7 Coastal processes and hydrodynamics

This chapter provides additional information to address the submissions received during the statutory public display period of the Project EIS. The key issues raised from the Project EIS submission process relevant to the coastal processes and hydrodynamics assessment are summarised Table 7.1.

Table 7.1 Summary of submission issues received in relation to the Project EIS coastal processes and hydrodynamics assessment chapter

Figure 7.2 Changes to the flood tide peak spring velocity (left) and ebb tide peak spring velocity (right) for the Project Channel and WBE reclamation area geometry case

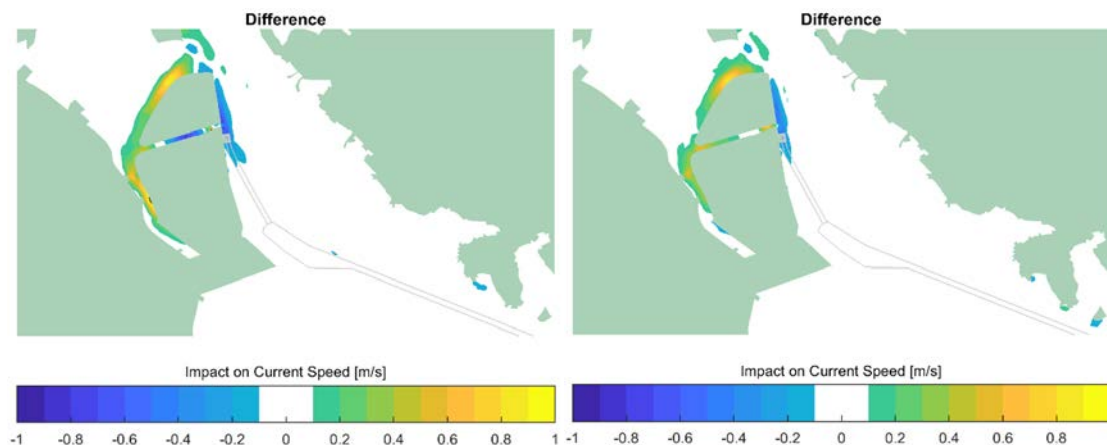
12.26	Predict the spatial extent of sediment dispersion from all tailwater release points and demonstrate that the water quality objectives would be met within a reasonable distance from these. Modelling should consider a worst case scenario where all release points were releasing simultaneously at the maximum TSS and at maximum release rate. Predictions should be made across varying tidal cycles and current velocities. Demonstrate that the release locations chosen for the release points provide the greatest potential for mixing and dilution and would result in the lowest risk to the receiving environment.	Section 9.13.2.3	Section 7.4		✓
		Appendix G	Appendix D	✓

AEIS Appendix D Section 4.3.2 provides the predicted velocity impacts from the construction of the WBE reclamation area. Figure 7.2 shows the proposed channel between the new reclamation areas has very good tidal flushing characteristics. The modelling undertaken as part of the Project EIS and AEIS has incorporated varying tidal cycles and current velocities.
